Response to the comments of Transport Department (as at 14 August, 2025)

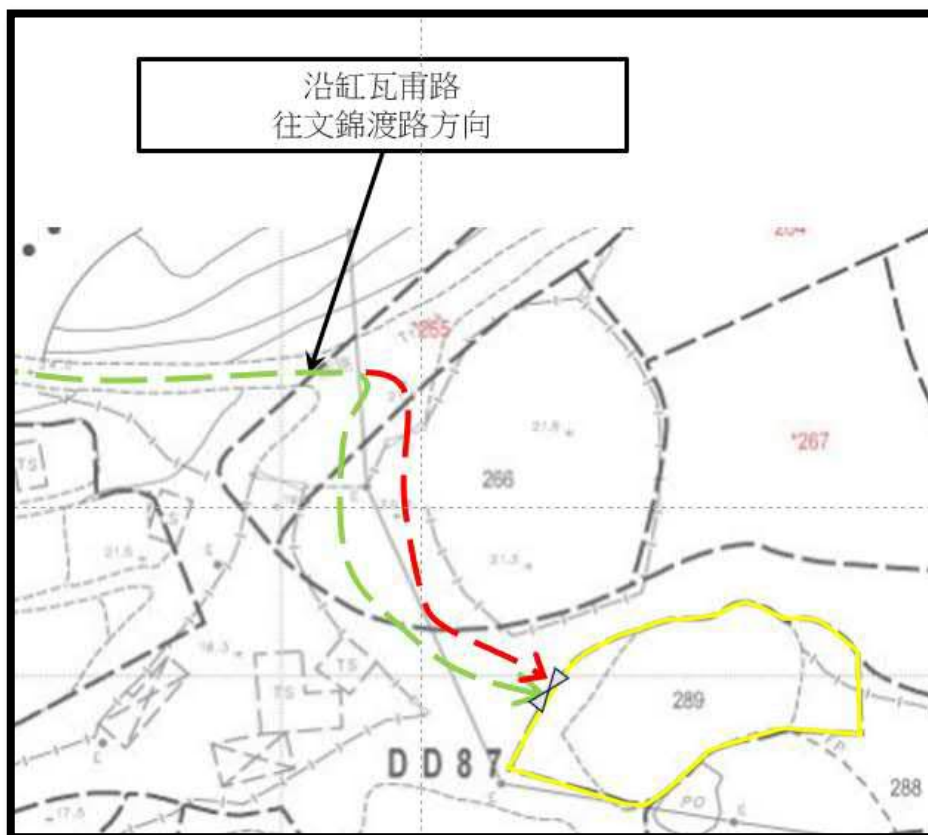
(ii) The applicant should provide a proposal and advise its adequacy on the vehicular access arrangement including the local access road leading to the development through private land and unallocated and unleased Government land. The applicant should also seek comments/approvals from the responsible parties to validate the feasibility for vehicular access at these locations;

知悉。跟據先前提文的 圖 2 - 車路圖，申請者已取得因車輛進出申請場地時需經過及使用地段 265 及 266 的業主同意。另外，申請者亦與業主洽談租務中，若此申請獲批的話，會租用地段 266 一併作貨倉之用。及增加多一條行車路線選擇使用(如下圖)。
